REMARKS

DRAWING AMENDMENTS

Figure 1
100

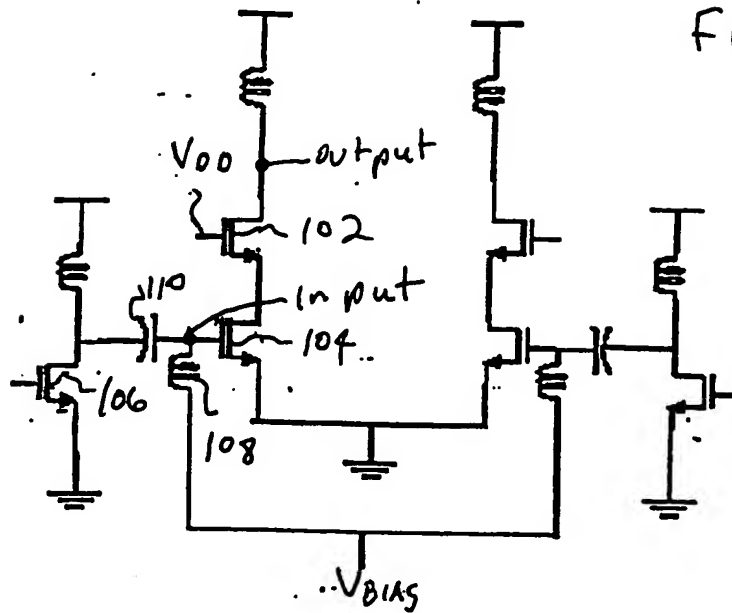
In the Office Action, the Examiner objected to the Drawings stating that Figure 1 should be labeled as "Prior Art" because only that which is old is shown. By the foregoing Amendment, Applicants have amended Figure 1 to accommodate the Examiner. Accordingly, Applicants respectfully request that the Examiner reconsider and remove the objection to the Drawings.

The attached sheet of drawings includes changes to Figure 1. This sheet, which includes Figures 1, 2, and 3, replaces the original sheet including Figures 1, 2, and 3. Figure 1 has been labeled "Prior Art."
